# DECLARATION FOR THE EXPLANATION OF SIGNIFICANT DIFFERENCES PINE STREET CANAL SUPERFUND SITE BURLINGTON, VERMONT April 2009

Pine Street Canal Superfund Site, Burlington, Vermont

## EXPLANATION OF SIGNIFICANT DIFFERENCES PINE STREET CANAL SUPERFUND SITE BURLINGTON, VERMONT April 2009

Attachment A – Figures

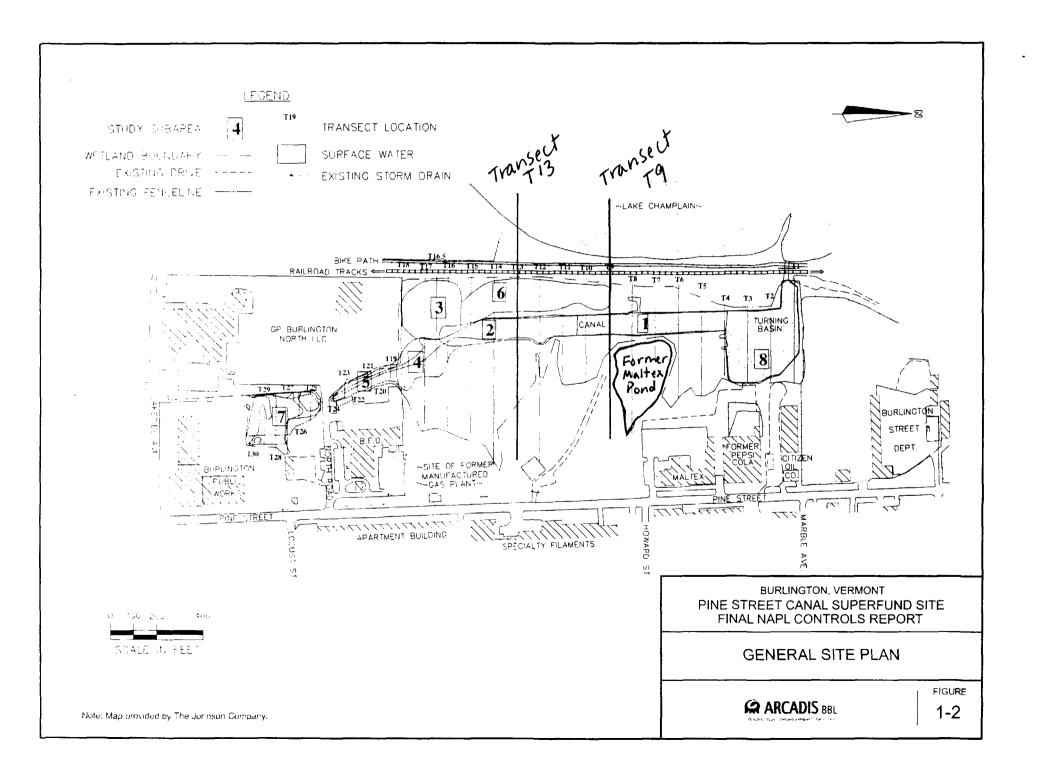
This ESD calls for a modification of the cap to address the ongoing migration of NAPL. In areas where NAPL is seeping (between transects T9 and T13 approximately, as shown on figure 1), the cap will be partially replaced and/or augmented with a new cap system that will capture NAPL before it is released into the canal. The NAPL that accumulates will periodically be removed and shipped off site for treatment or disposal in an approved facility.

In those areas where the scepage of contaminants is occurring (T9 to T13, approximately), this ESD provides that the existing cap will be redesigned and reconfigured to intercept and sequester the NAPL, preventing its release into the canal. The specifications for the new cap profile and the selection of materials for the cap will be finalized during design. It is expected that the new cap will include a high-permeability layer that will facilitate passive collection and removal of

One possible design for the reconfigured cap is described as "Alternative 2" in the June 2008 Final NAPL Controls Report. Alternative 2 would modify the existing cap between T9 and T13, approximately, with the addition of two new layers. The first would be a comprised of high-permeability, lightweight material (e.g., pumice) in which slotted pipes would be laid to facilitate NAPL capture and removal. This layer would be covered with a reactive cap in which an absorbent material (e.g., organoclay) at the core of the cap binds with the contaminant and prevents its release. When the capacity of the absorbent material is reached, the reactive cap must be replaced. However, it is expected that most of the migrating NAPL would accumulate in the underlying high-permeability layer before it reached the reactive cap, thereby minimizing the need for change-out. The new cap with its NAPL capture layer would require a more complex operation and maintenance program than did the original sand cap.

Some microdredging of the existing sand cap is expected during installation of the new cap to remove NAPL-impacted cap material and maintain a weight balance so as not to trigger additional consolidation of the native sediment. Microdredging is also need to minimize changes to the canal profile and to maintain, to the extent practicable, the original elevation of the bottom of the canal.
